ADDENDUM NO. 2

JUNE 1,2022

READING MUHLENBERG CAREER & TECHNOLOGY CENTER

PROGRAM UPGRADES

8 HOISTWAY DETAIL

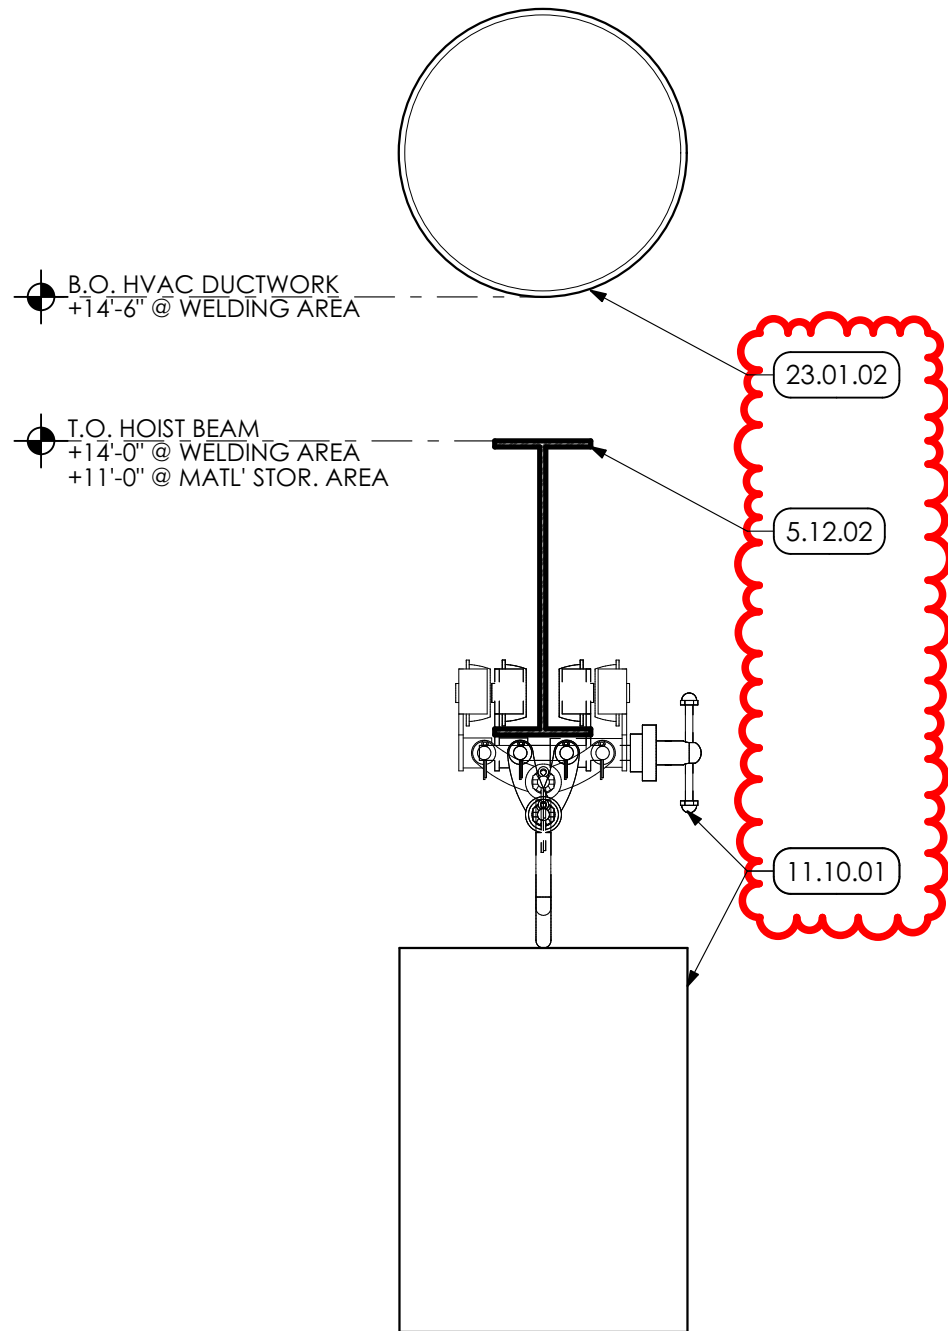
8. **Sheet A-502, Drawing 8, Hoistway Detail: MODIFY** Viewpoint to read key notes. Refer to SD-002 which is attached to and made a part of this Addendum.

4 STOREFRONT ELEVATIONS | SPEC. 084113
 SCALE: 1/4" = 1'-0"

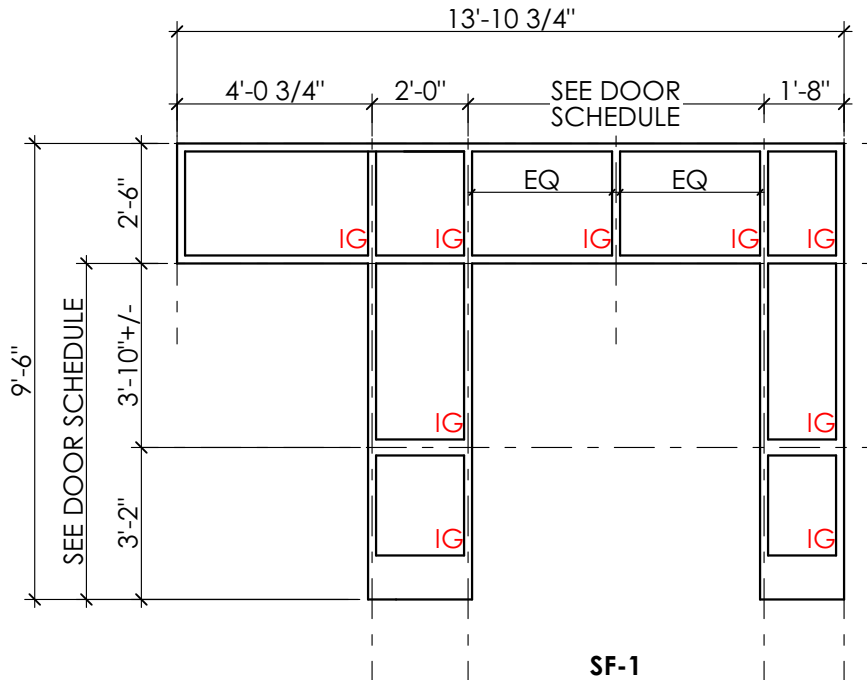
12. **Sheet A-601: MODIFY** storefront SF-1 glazing to insulated glass. Refer to SD-003, which is attached to and made a part of this Addendum.
13. **All Sheets: MODIFY** Keynote 5.12.12 to read as follows: STEEL DUCTWORK SUPPORT BY H.C. COORDINATE w/ STRUCTURAL DRAWINGS.

Hi Brad and Jim,
All glass indicated on drawing A-601 says LG (Laminated glass), but SF-1 is an exterior door and frame, do you want Insulated glass?

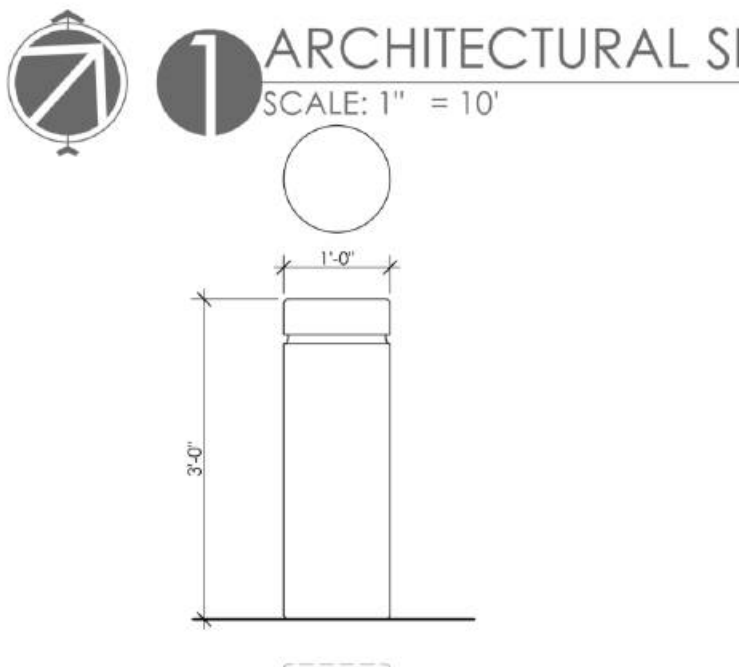
Hi Jim,
The bollard spec doesn't match the drawings- please clarify what is required.

B. Bollard Construction:

1. Type 'A' Bollard; 12-inch Diameter, min. by 30-inch height: See dr: selected product.

Good Morning Steve,
The spec. will be updated to read 12" dia. x 36" ht. as shown on the drawing.
Thank you,

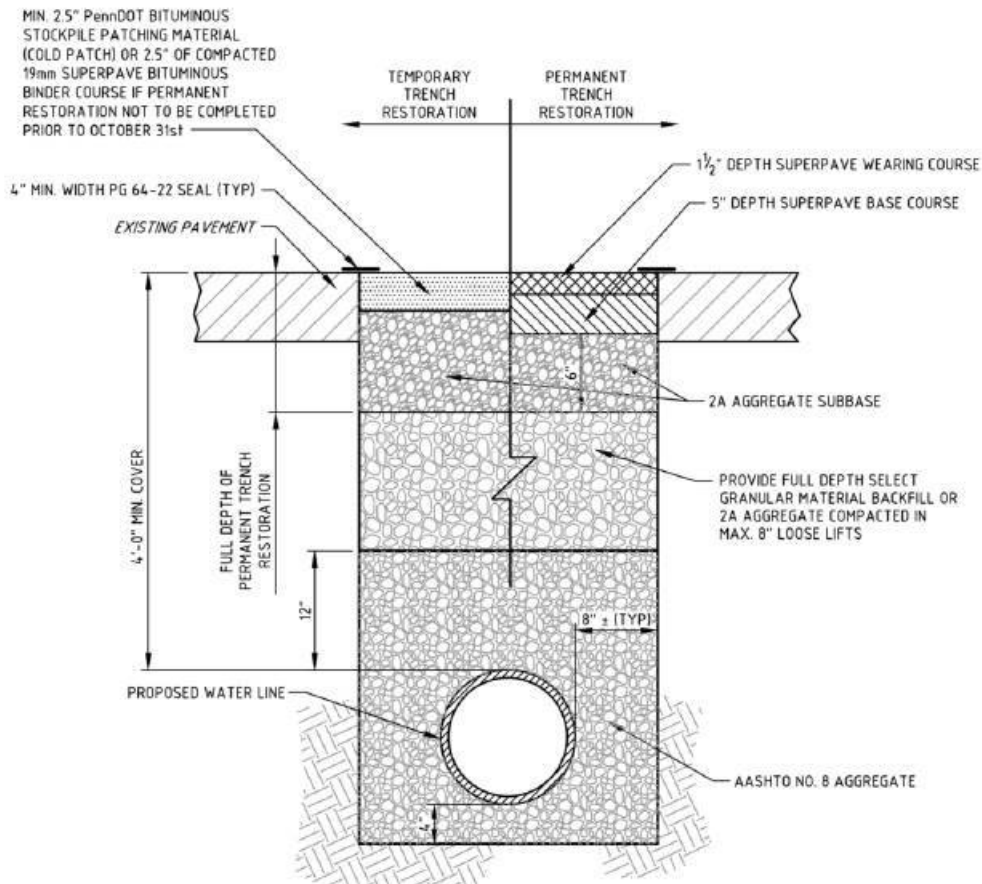
This was more the question- 2 details below. Are you stating that at the trenches, it is the first section (no milling) but at where the existing paving is meeting new paving at the building- you do want it milled(lap joint detail)?

The left side of the detail is for **temporary** trench restoration if permanent restoration will not be completed prior to October 31st as indicated in the note on the drawing. The right side of the detail is for final permanent restoration of the trench which is required.
